NEW AIRPORT HANGAR DOOR HARTNESS STATE AIRPORT SPRINGFIELD, VERMONT

SHOP DRAWING REVIEW

WILSON INDUSTRIAL DOORS, INC.
 P. O. Box 372 ELKHORN, WISCONSIN 53121 • DU 045446 1-800-558-5974
 NAME: State of Vermont Dept. of State Buildings
 ADDRESS: 4000 Rikers Ave, Montpelier, VT. 05602
 SIZE: 52'-1\"/>
 x 13'-11\"/>
 DATE: 3/11/91

C1

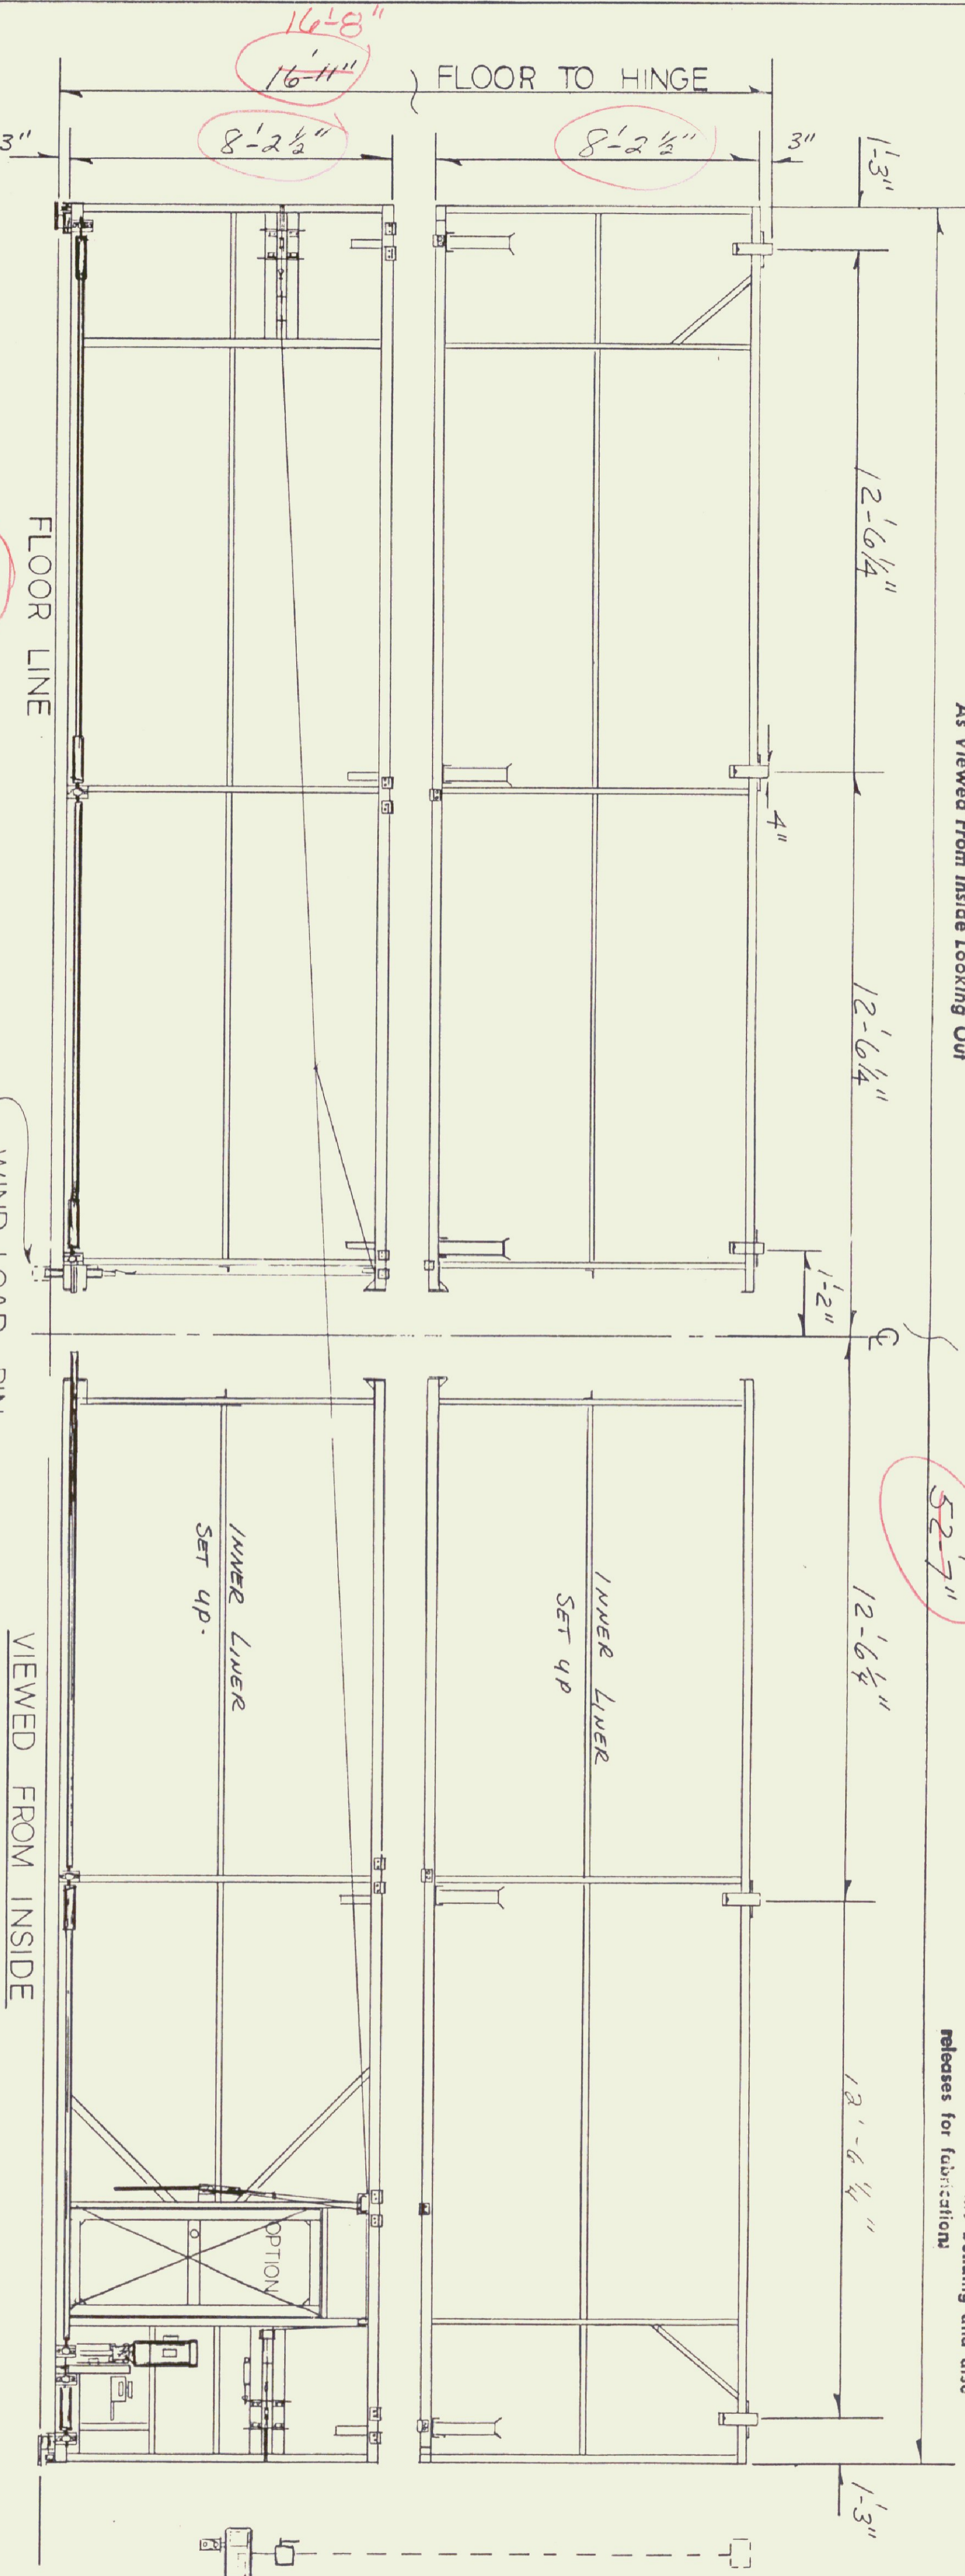
- No Exception Taken
- Revise and Resubmit
- Make Corrections Noted
- Comments Attached

This check is only for review of general conformance with the design concept of the project and general compliance with the information given in the contract documents. The contractor is responsible for confirming and correlating all quantities and dimensions and performing his work in a satisfactory manner.

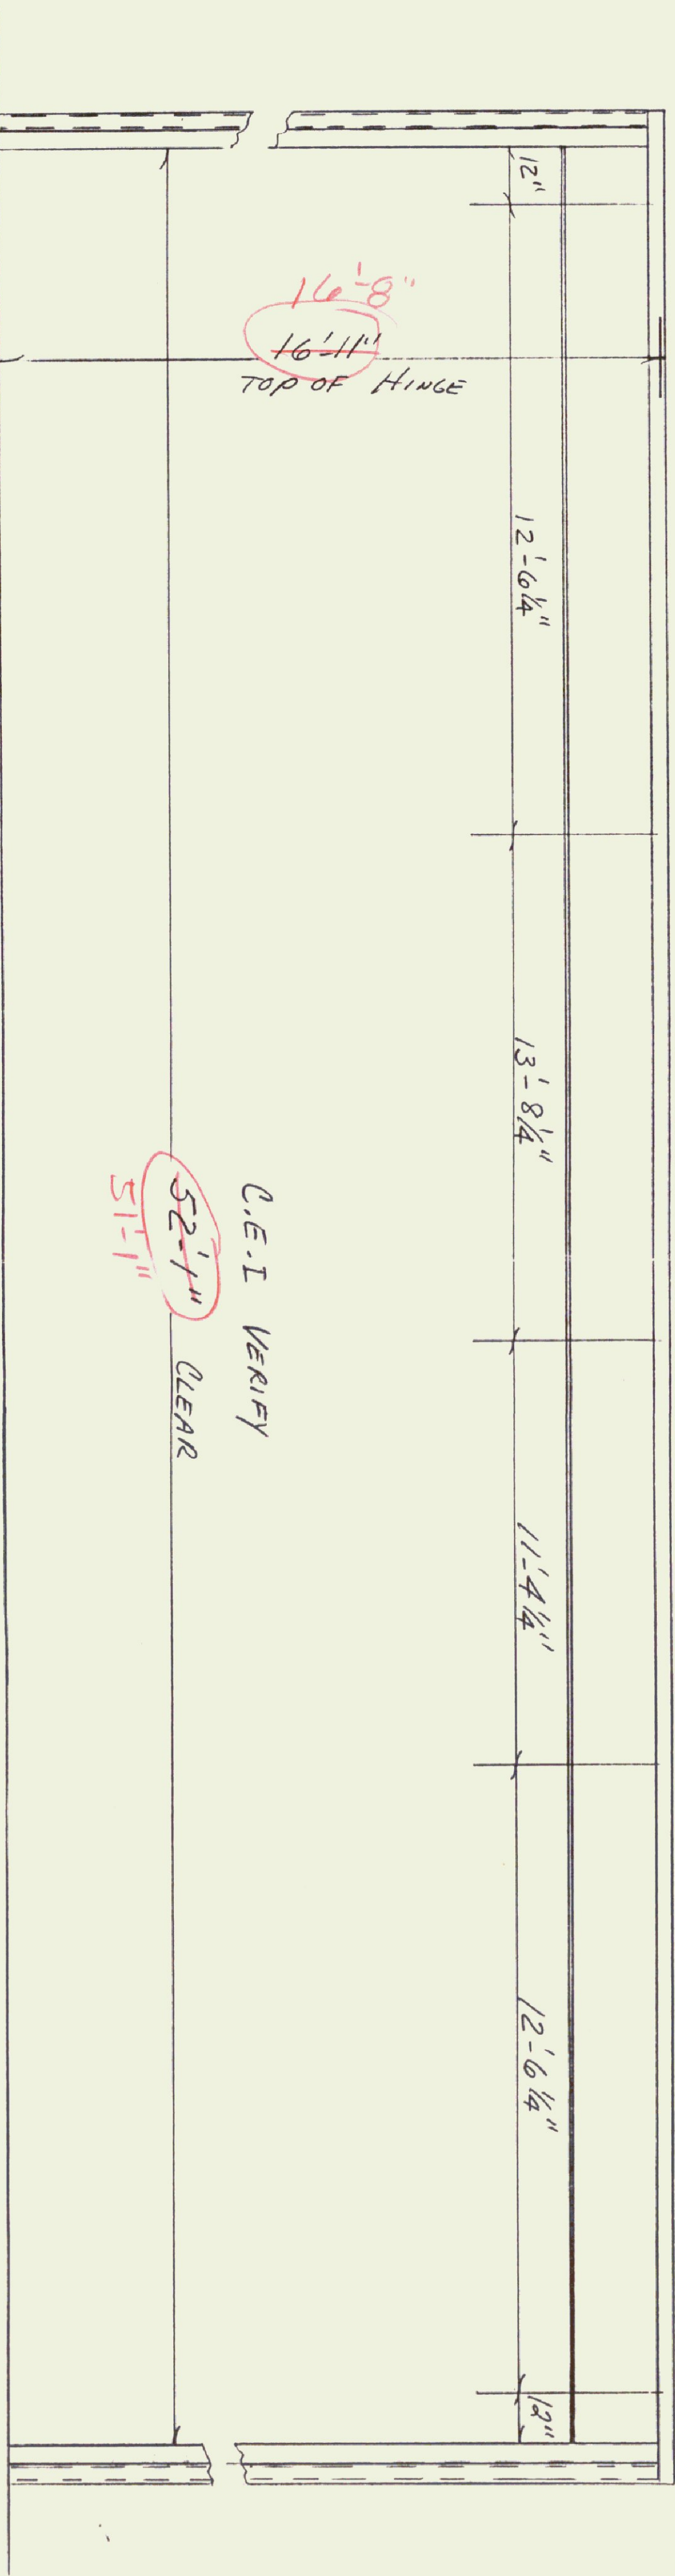
L 6X4X 3/8
3/8" x 4" PLATE
52'-1"
51'-1"
C.E.I. - FIELD VERIFY

C.E.I. VERIFY
52'-1"
51'-1"
CLEAR
